STAFF REPORT ADDENDUM

APPLICATION PCA 1999-HM-037
Concurrent with SEA 97-H-070-03
and RZ/FDP 2016-DR-001

APPLICANT: NVR, Inc.

PROPOSAL: To permit the deletion of 11.95 acres from RZ 1999-HM-037 to permit the site to be rezoned to PDH-30 as part of RZ/FDP 2016-DR-001.

Figure 3- Proposed Garage Layouts and Trash/Recycling Bin Spaces

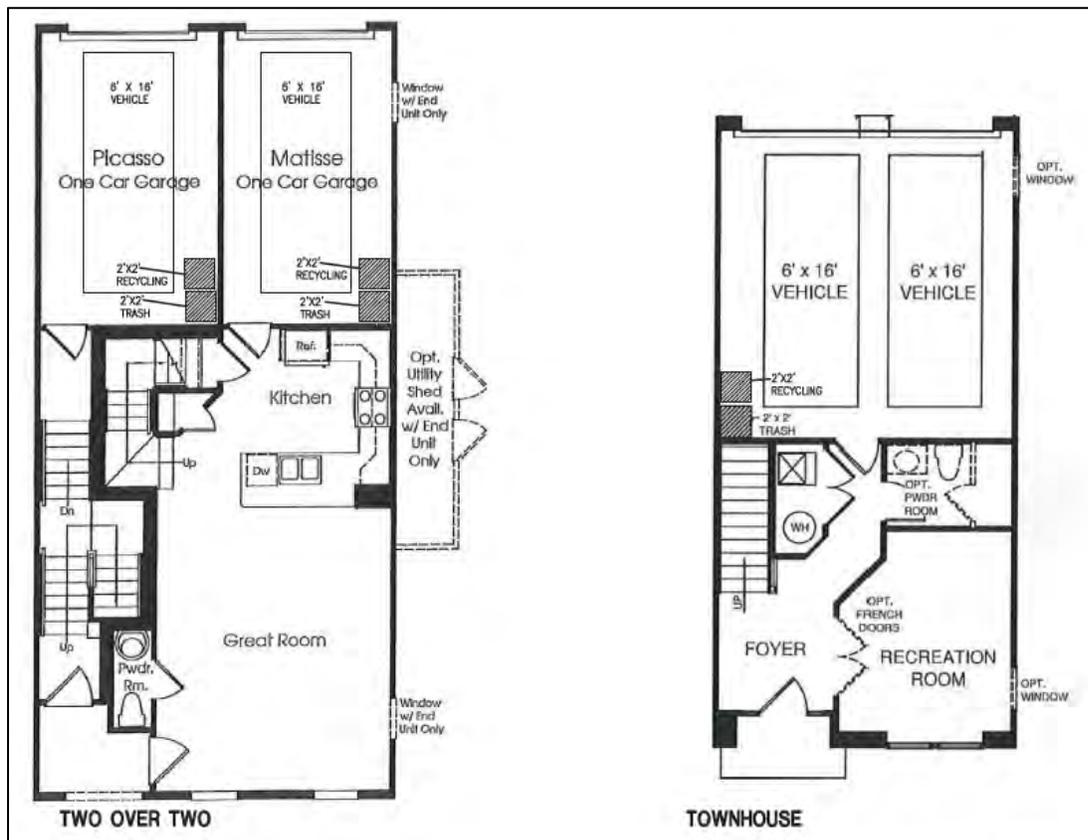
The Planning Commission also requested additional information about the interior layout of the garages for all units and the placement of garbage and recycling receptacles. Figure 3 depicts the garage layout of the vehicles and receptacles.

Figure 4- Linear Park and Proposed Location of Fence

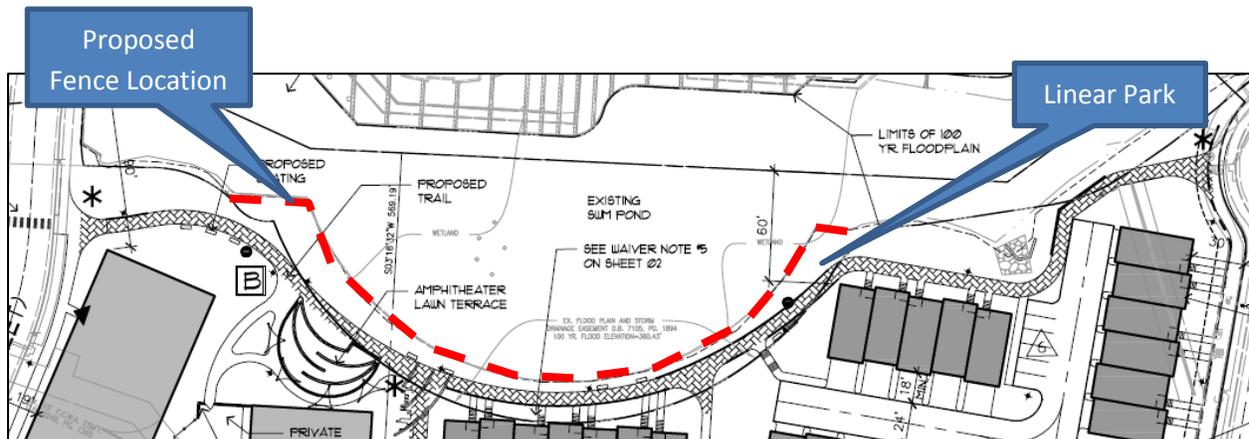
there was no existing bench as outlined above, staff recommended the applicant install a fence to increase the safety of pedestrians enjoying the linear park. The applicant has proposed a black wire fence, a minimum of 36 inches and a maximum of 42 inches along the length of the existing concrete bulkhead as shown below in Figures 4 and 5. Staff believes that the proposed fence will provide an additional safety measure that will minimally impede the viewshed of the pond and other amenities.
